Extending Power via MDI for IEEE 802.3BT, BASELINE

Purpose

To extend the existing PoE TLV to encompass IEEE 802.3BT additions.

pse_dll_power_type

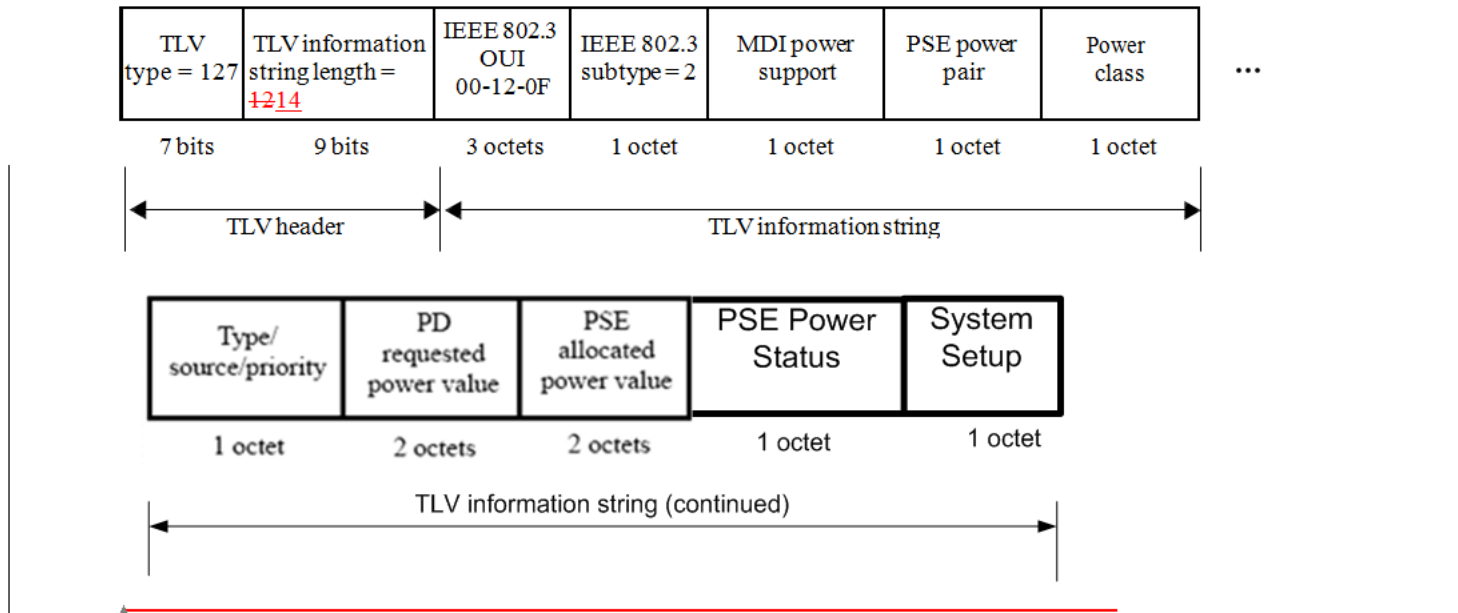
A control variable that indicates the type of the PSE by which the PD is being powered.

Values: 1:PSE is a Type 1 PSE (default).

2: PSE is a Type 2 PSE.

3: PSE is a Type 3 PSE.

4: PSE is a Type 4 PSE.
